Agenda
Village of Arlington Heights
Design Commission
Community Room, 3rd Floor

Arlington Heights Village Hall
33 S. Arlington Heights Road
Arlington Heights, IL 60005
February 9, 2016
6:30 PM

**MINUTES OF
THE VILLAGE OF ARLINGTON HEIGHTS
DESIGN COMMISSION MEETING
HELD AT THE ARLINGTON HEIGHTS MUNICIPAL BUILDING
33 S. ARLINGTON HEIGHTS RD.
JANUARY 26, 2016**

SHEET NO.
A6.1

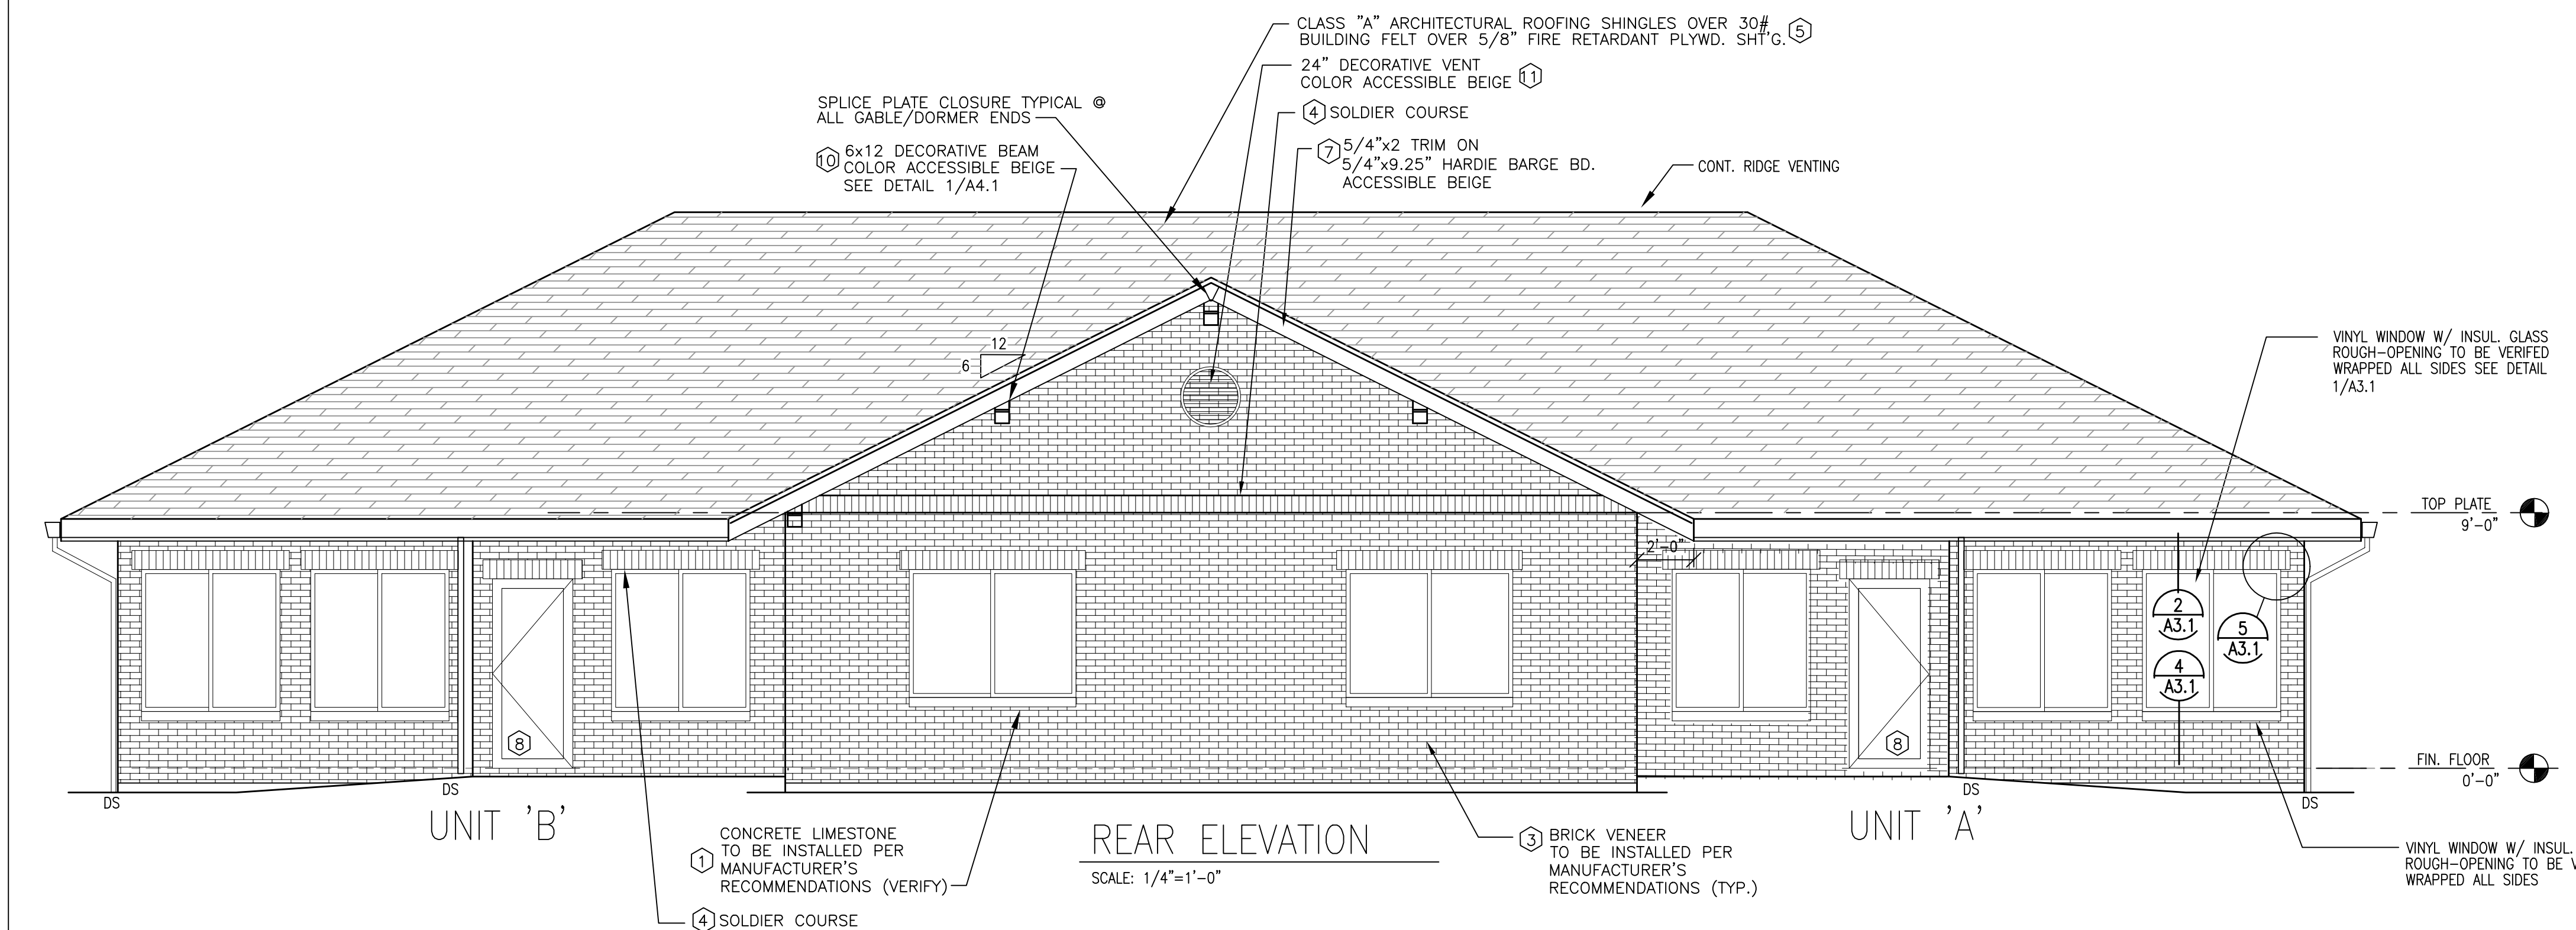
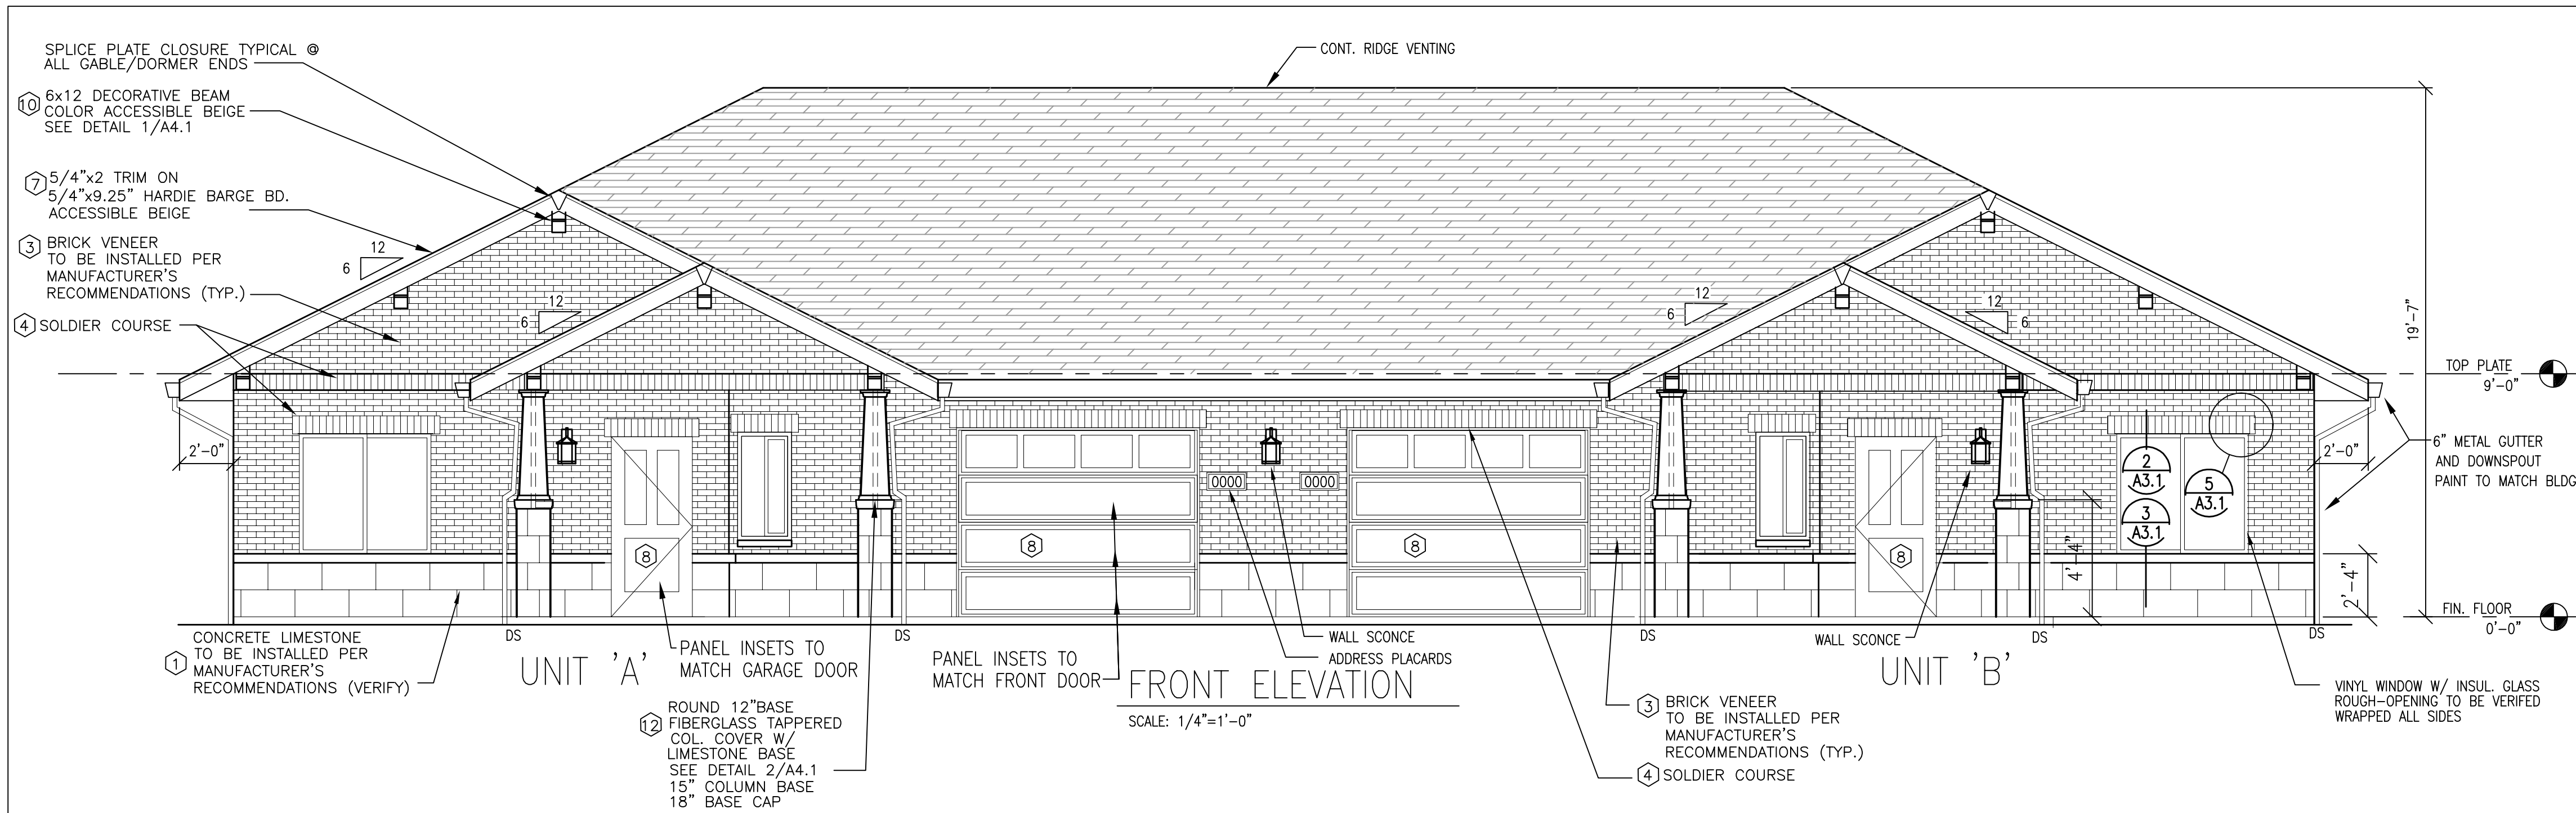
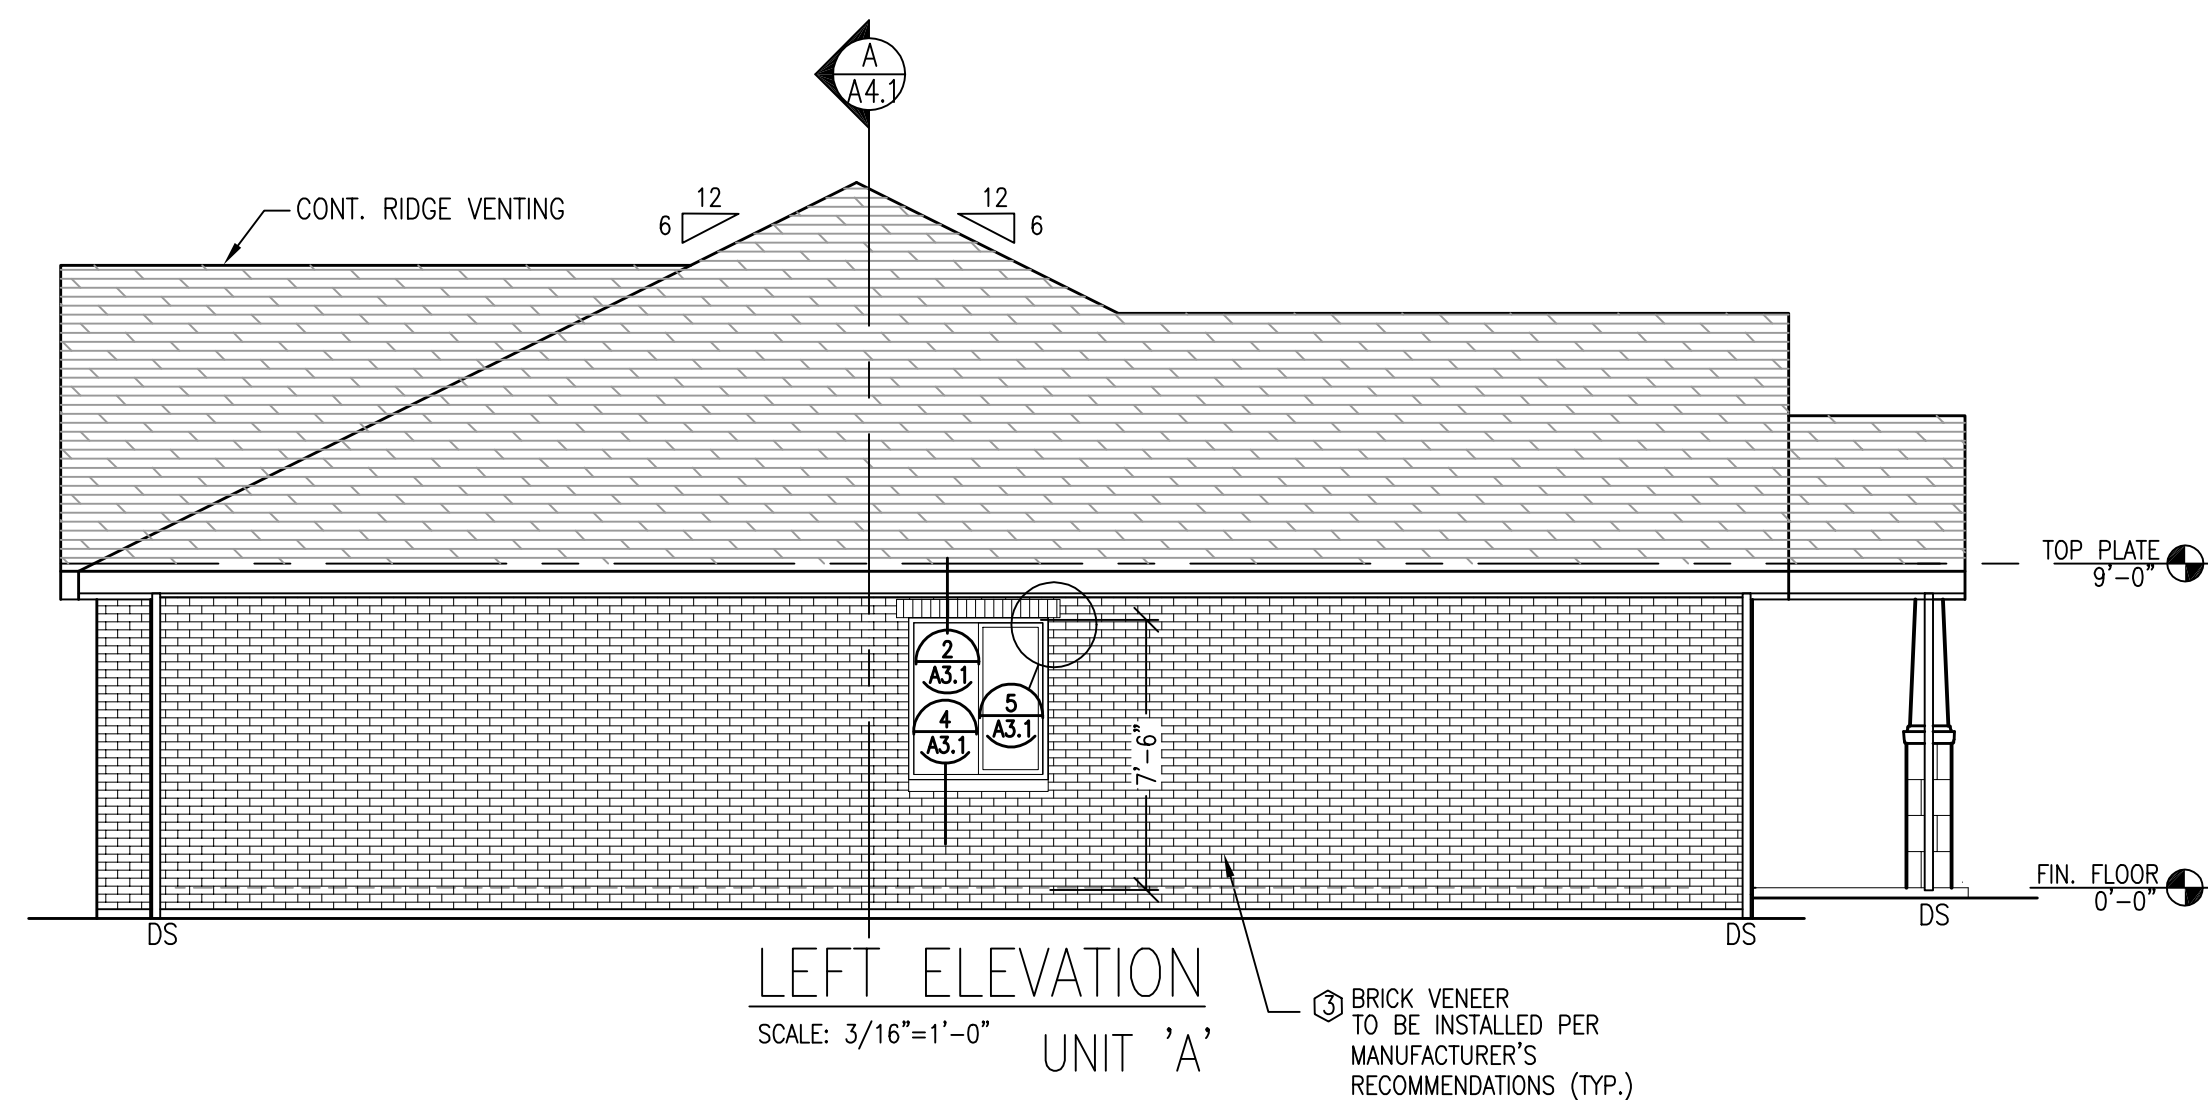
1. It is recommended that the rooftop equipment be moved to the courtyard side of the roof so that it will not be visible.
2. In place of the mechanical screen, provide two of the decorative triangular dormers on the east side of the roof to break up the expanse of roofing and to match the other sides of the building.

3. Relocate the rooftop mechanical equipment to the courtyard side of the roof.
4. Provide two decorative triangular dormers on the east side of the roof.
